## Historic Architectural Review Commission Staff Report for Item 12

Application Number: H2022-0032

Address: 1400 Grinnell Street

New two-story addition. New one-story accessory structure.

*First floor and second floor plans with highlighted additions.*

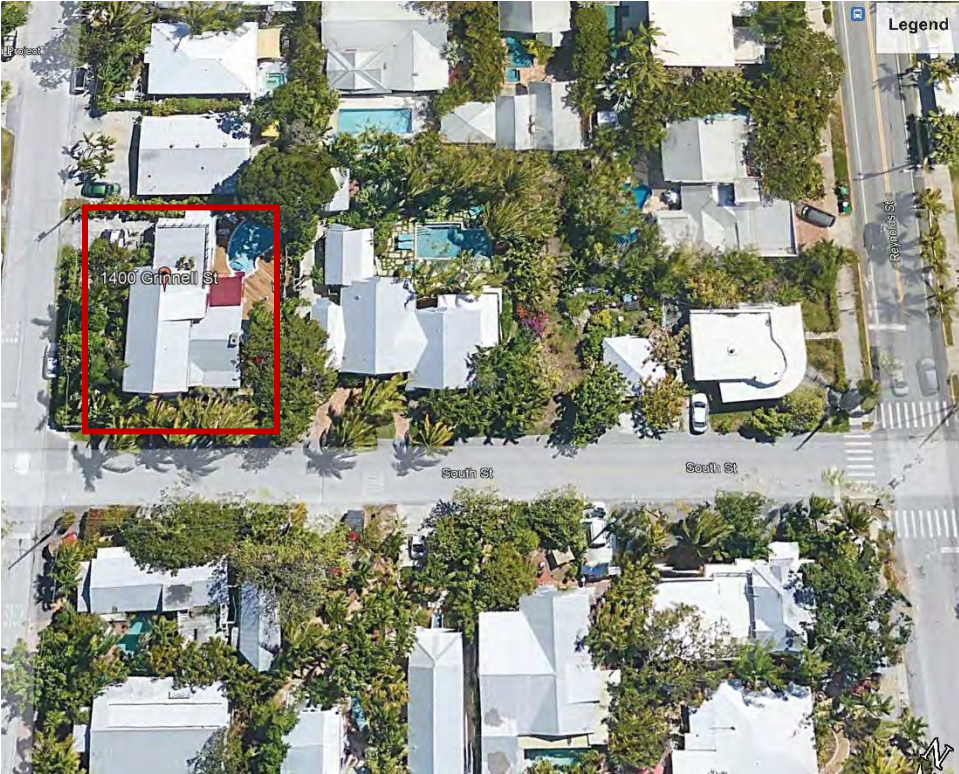
It is staff's opinion that the proposed design fails many of the cited guidelines. The scale and massing of the existing building is foreign to its urban context and adding more massing to an existing large building is contrary to the guidelines. It is staff's opinion that the proposed two-story addition will make this building more out of scale than what it is today. Staff also finds that the accessory structure does not meet cited guidelines for new construction. The accessory structure, which will be 7 feet setback from the street side property line, will have a maximum height of +-16 feet, and will become a prominent structure within the street. Accessory structures should be complementary and secondary structures to the existing streetscape. Staff finds that the width, depth, and height of the building are too large for the area on the site where it is proposed, and

there is minimum space (3 feet) between the new proposed 16 feet tall structure and the principal two-story 27 feet tall building. Staff has reviewed the proposal with the understanding that new construction must meet flood regulations requirements, but there are ways to lower the height of a structure without compromission appropriateness.

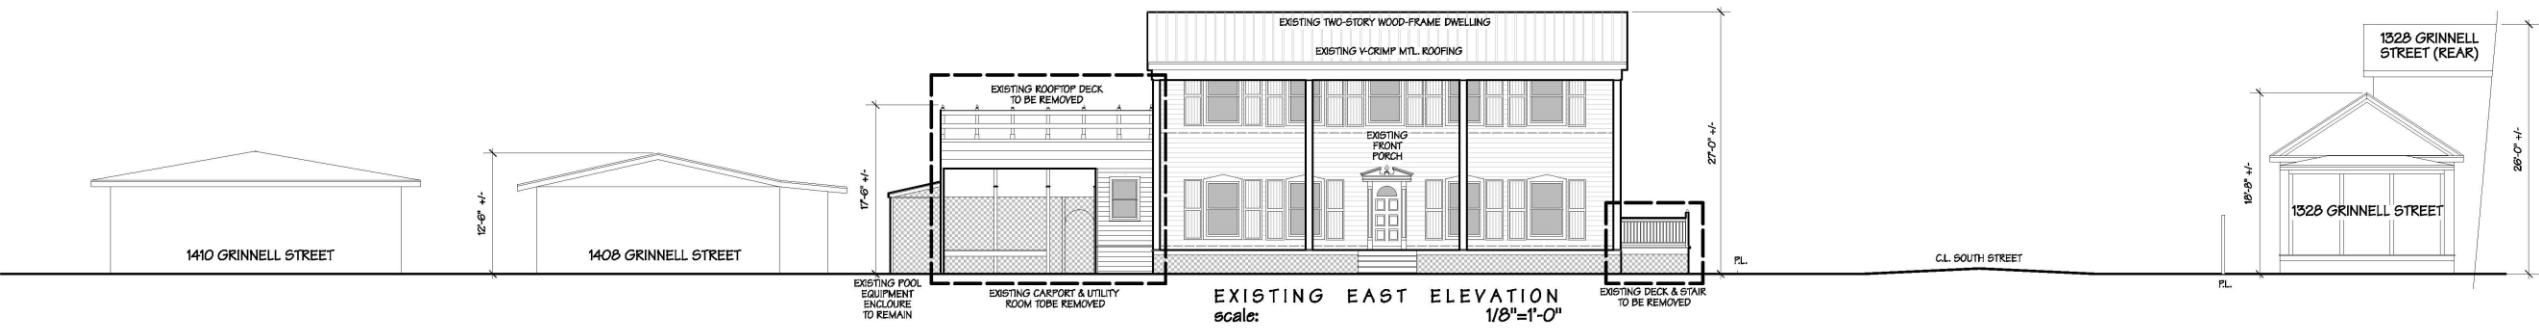
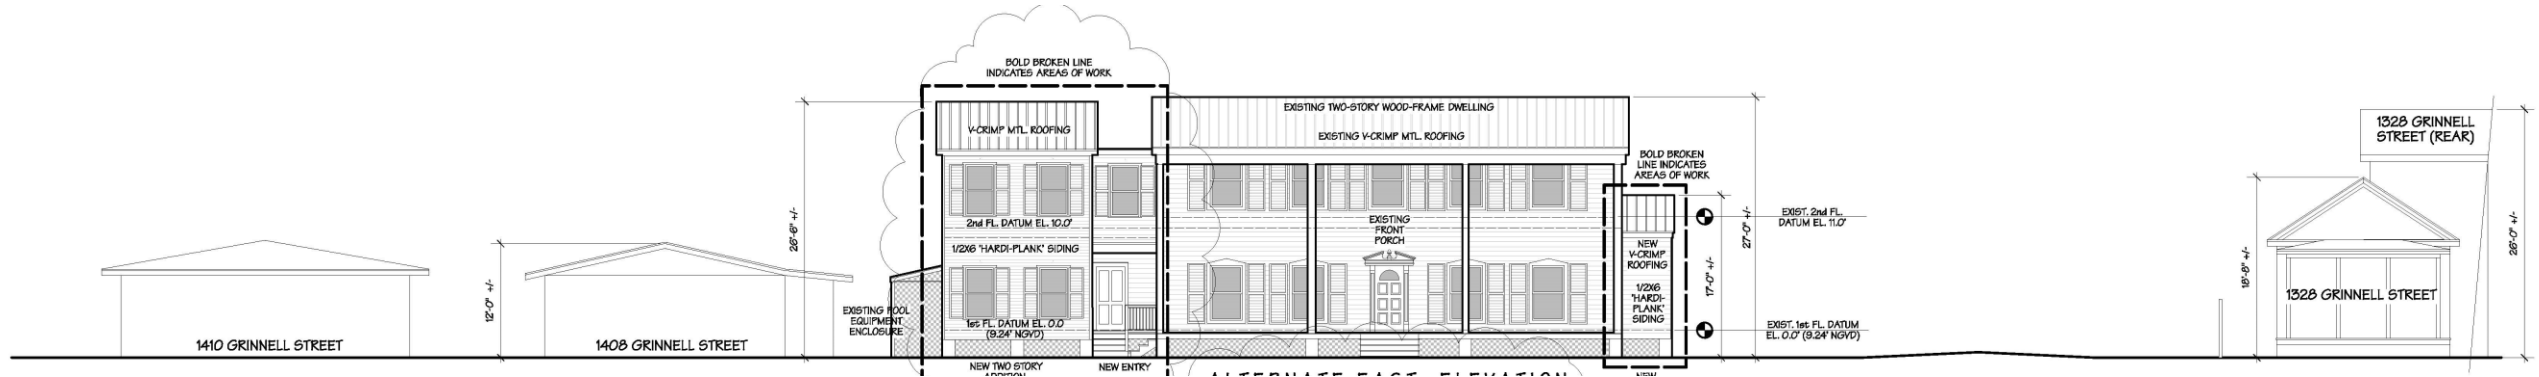
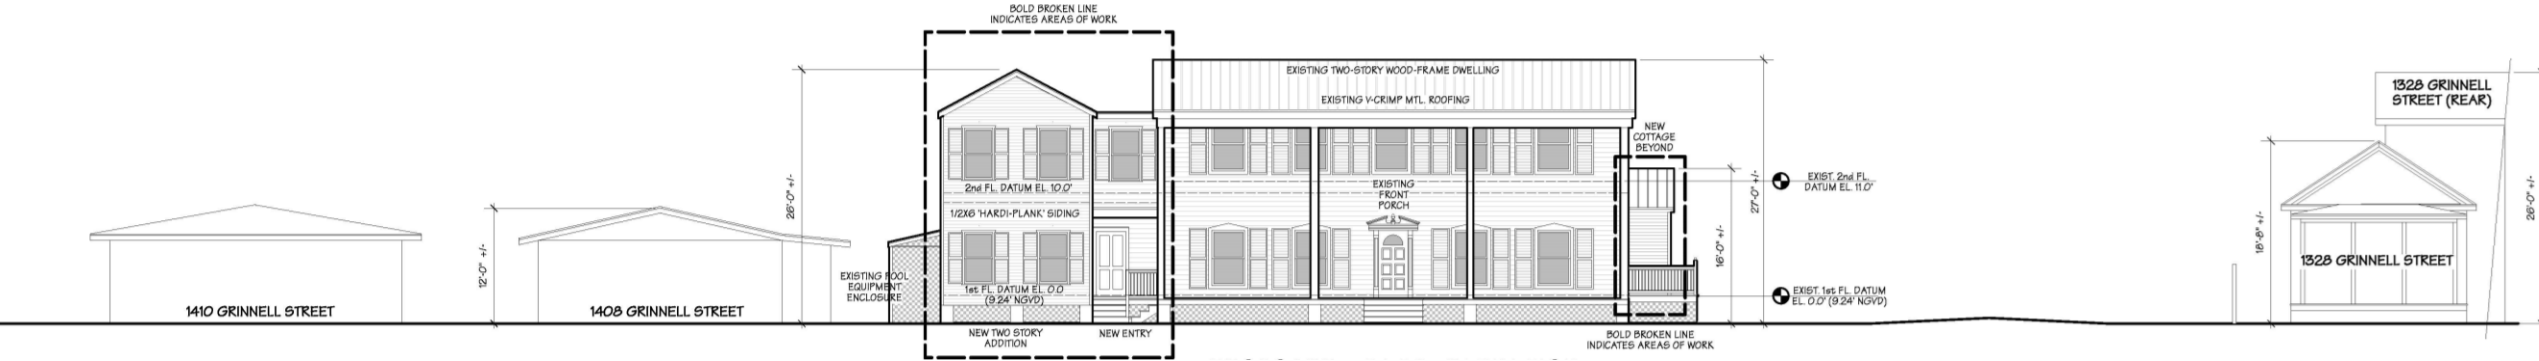
The two-story addition will have a front gable roof and a recessed two-story volume with a flat roof that will connect it to the main house. The connector will have a small one-story porch and the exterior wall will be setback from the front elevation of the principal house approximately 2'-6". The maximum height of the structure will be approximately 26'-0" from grade, a foot lower than the main house. The south elevation will have no fenestrations, while the east and west elevations will have aluminum windows. The structure will have hardi board siding and 5 v-crimp metal panels as the finish material for the roof. A graphic depicting existing front street view, the denied proposal and the new proposal is part of this report.

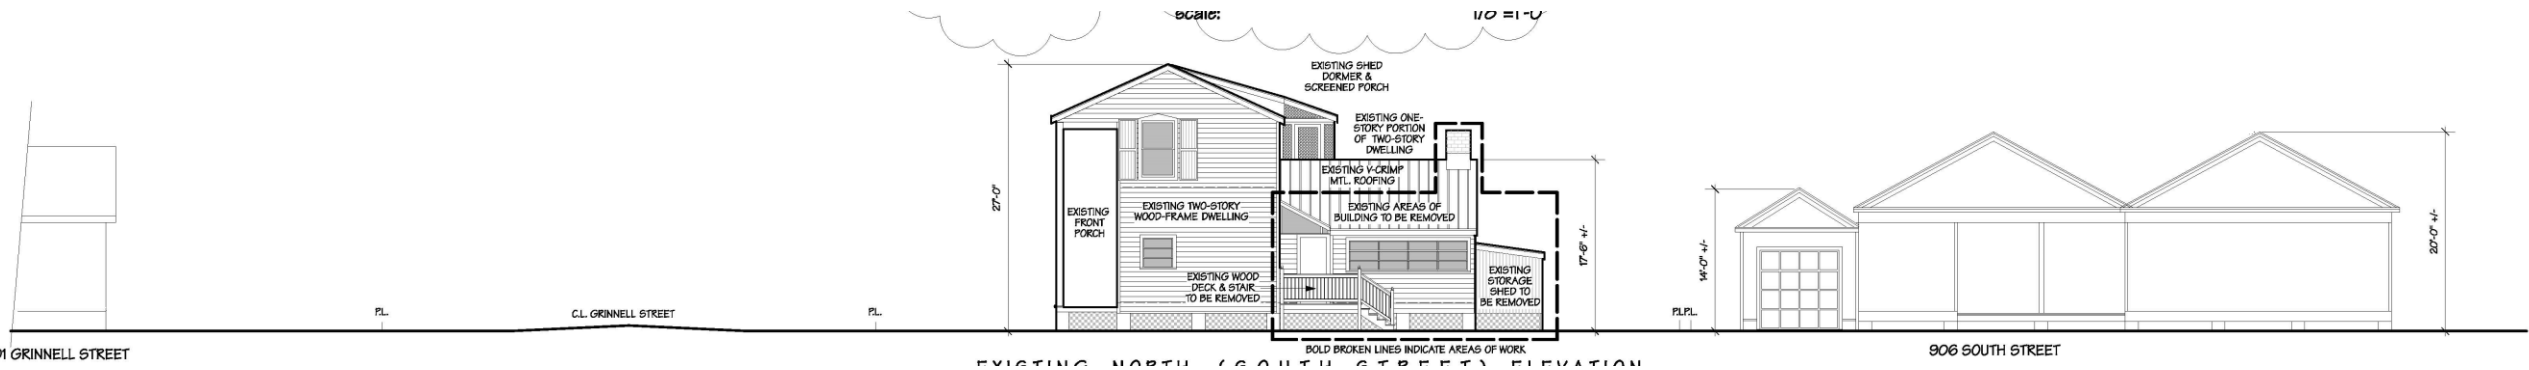
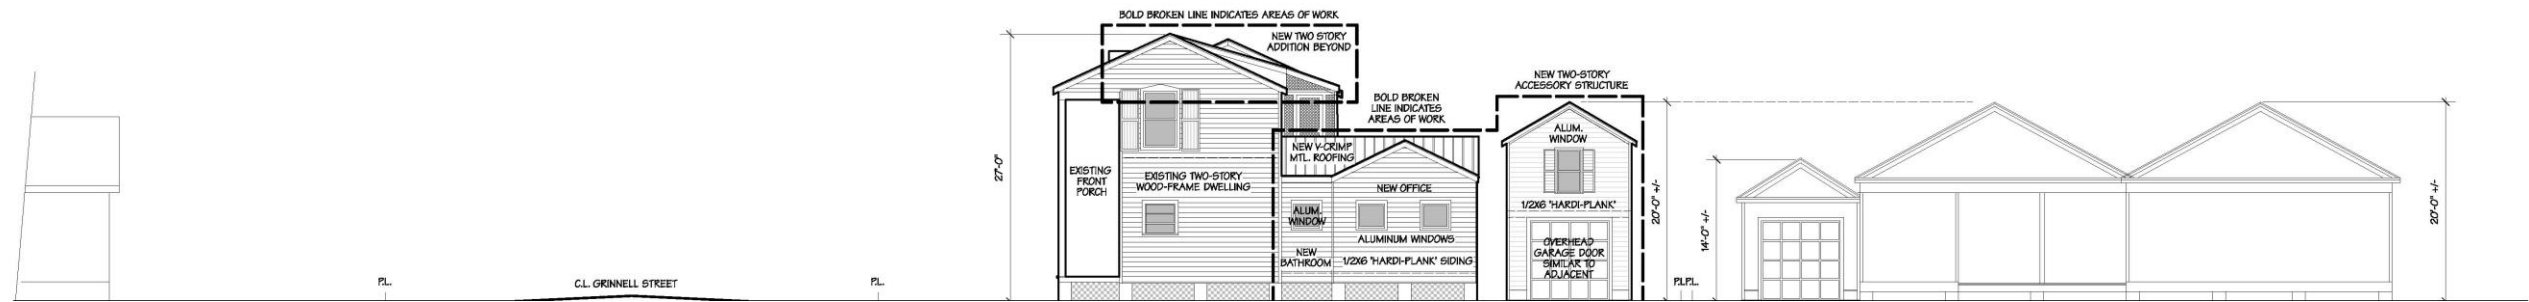
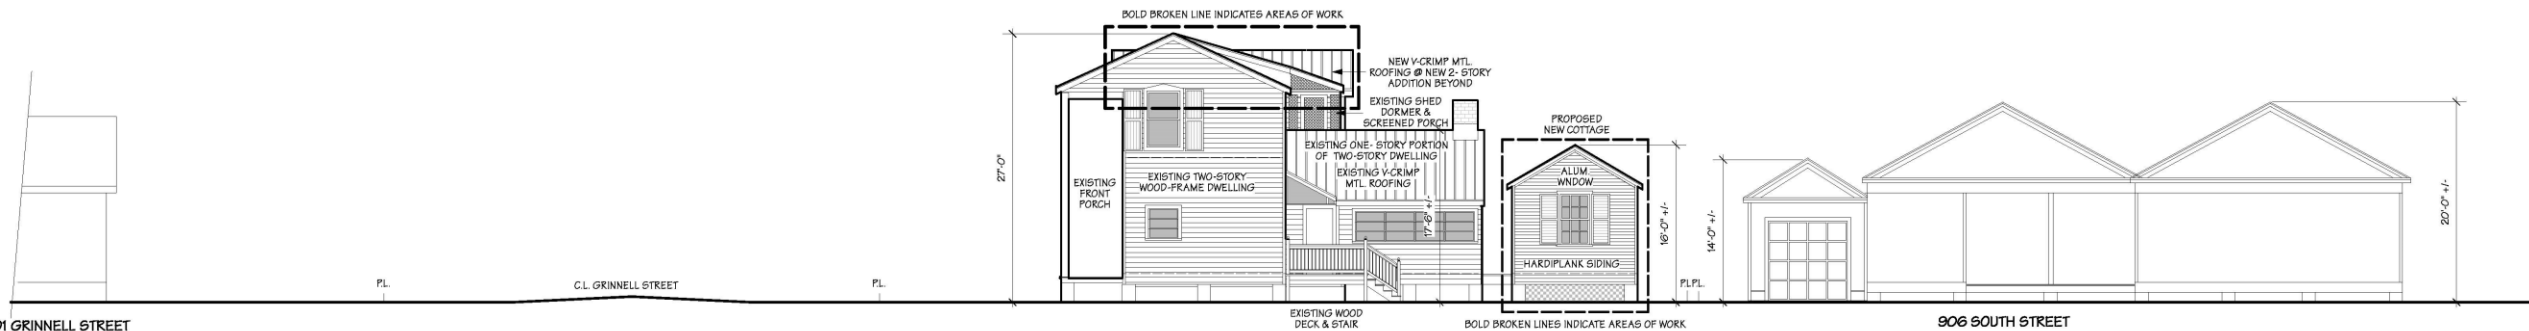
In addition, the design includes a one-story accessory structure located on the rear yard and facing South Street. The structure will be elevated over concrete piers and will be approximately 7 feet setback from the property line; 5 feet closer to the South Street property line than the principal house, which is 12 feet setback from the street side boundary. Maximum height from grade will be +16 feet. The structure will have a front gable roof and a window will be the only fenestration facing the street. Aluminum windows and doors, hardie siding and 5 v-crimp will be the exterior materials used to finish the structure.
